STAFF REPORT
(Preliminary Plat)

CASE NUMBER: S/D 90-12 - WESTPORT INDUSTRIAL PARK 6TH ADDITION

STAFF REPORT
(Final Plat; Preliminary Plat, Approved 3/22/90)

CASE NUMBER: S/D 90-12 - WESTPORT INDUSTRIAL PARK 6TH ADDITION

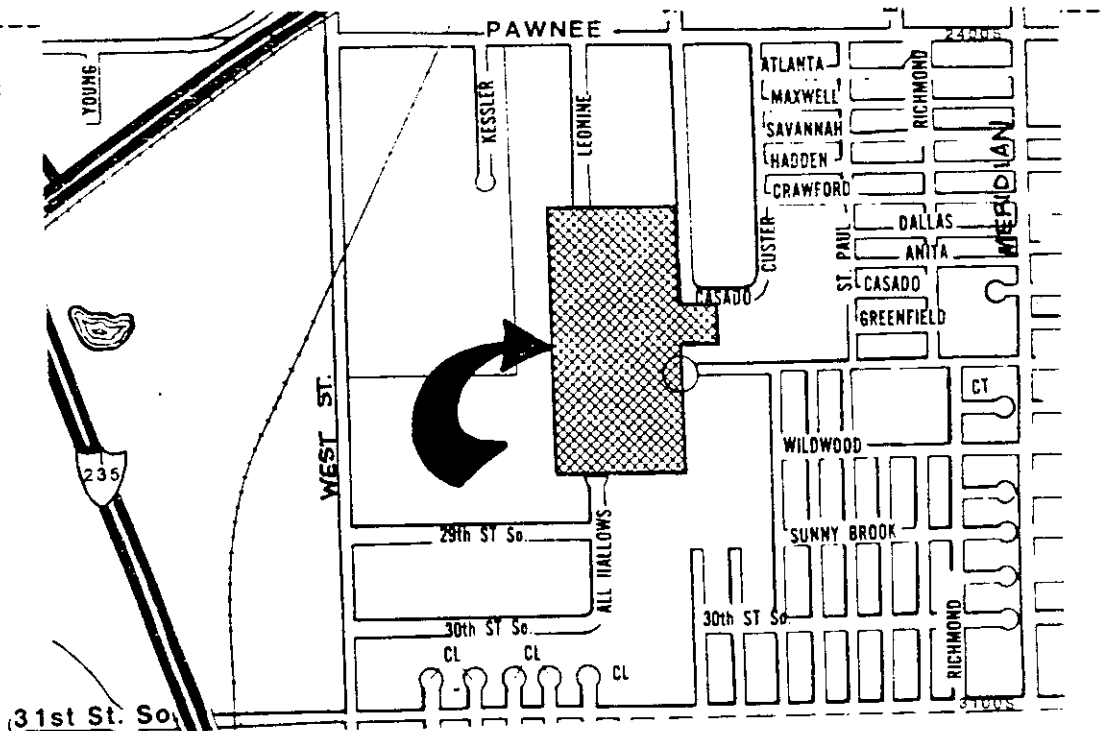
NOTE: Except for lot 8 which is already zoned "E" light industrial, a zone change (Z-2988) has been requested for the entirety of the site, from "AA" one family to the "E" light industrial zoning district. This zone change request is scheduled to be heard by the Planning Commission on March 15, 1990.

- A. The applicant shall guarantee the extension of sanitary sewer to serve the lots being platted.
- B. The applicant shall guarantee the extension of City water to serve the lots being platted.

- C. The applicant shall guarantee any drainage improvements required by the platting of this property.
- D. The applicant shall guarantee the paving of the proposed interior streets. This guarantee shall include the paving of a cul-de-sac for the proper termination of All Hallows at the south end of this site.

- G. The applicant is advised that a Westport Industrial Park Fifth Addition has been platted and consequently this plat shall be designated as the Sixth Addition.

- H. On the final plat, angles and bearings shall be indicated for the drainage dedication and appropriate dimensions provided from lot corners.
- I. The final plat shall reference a tie point to a previously platted lot corner or section corner.

- J. Prior to or at the time of submitting the final plat, the applicant shall submit a drainage plan to City Engineering for review and approval.
- K. The applicant shall install or guarantee the installation of all utilities and facilities which are applicable and described in Article 8 of the MAPC Subdivision Regulations.

- M. The applicant's engineer is advised that the Register of Deeds is requiring the name(s) of the notary public, who acknowledges the signatures on this plat, to be printed beneath the notary's signature.
- N. The representatives from the utility companies should be prepared to comment on the need for utility easements to be platted on this property.
- O. The representative from City Engineering should be prepared to comment on the status of the applicant's drainage concept. Also, Engineering needs to indicate if the boundaries of the drainage dedication are adequate, if minimum building pad elevations are required, and if any additional utility easement is needed for the existing sanitary sewer line along the east line of this plat.

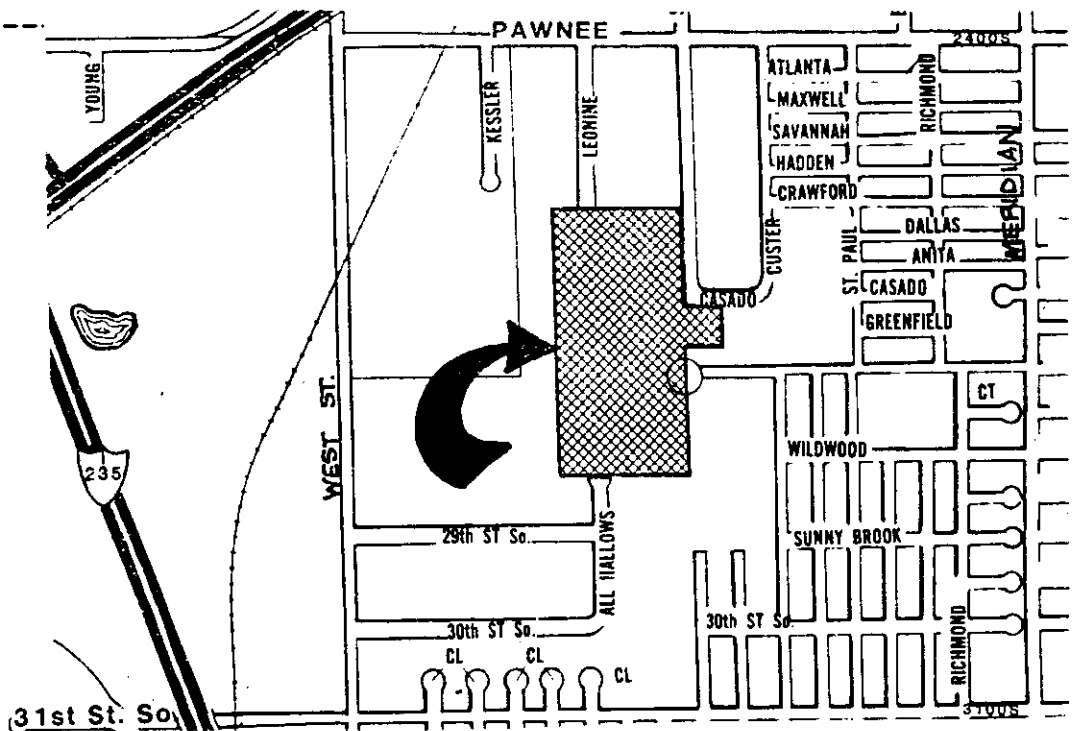
NOTE: Lot 9 on the preliminary plat has been split on the final plat to create Lots 9 and 10. Except for lot 8, which is already zoned "E" Light Industrial, a zone change (Z-2988) has been requested for the entirety of the site, from "AA" One Family to the "E" Light Industrial zoning district. ←

- A. The applicant shall guarantee the extension of sanitary sewer to serve the lots being platted.
- B. The applicant shall guarantee the extension of City water to serve the lots being platted.

- C. The applicant shall guarantee any drainage improvements required by the platting of this property.
- D. The applicant shall guarantee the paving of the proposed interior streets. This guarantee shall include the paving of a cul-de-sac for the proper termination of All Hallows at the south end of this site.

- F. On the final plat, bearings shall be indicated for the drainage dedication.
- G. Since a portion of this plat is of a previously platted lot, on the final plat tracing the engineer's text shall make reference to K.S.A. 12-512(b) regarding building setbacks, utility easement, and drainage easements.

- H. On the final plat tracing, the name of the president of Mid-States Construction Co., Inc. shall be printed under their signature block.
- I. The applicant shall install or guarantee the installation of all utilities and facilities which are applicable and described in Article 8 of the MAPC Subdivision Regulations.

- K. Perimeter closure computations shall be submitted with the final plat tracing. Section 5-101(c).
- L. Recording of the plat within 30 days after approval by the City Council.

- M. The representatives from the utility companies should be prepared to comment on the need for utility easements to be platted on this property.
 - N. The representative from the City Engineer's office should be prepared to comment on the status of the applicant's drainage plan.
-
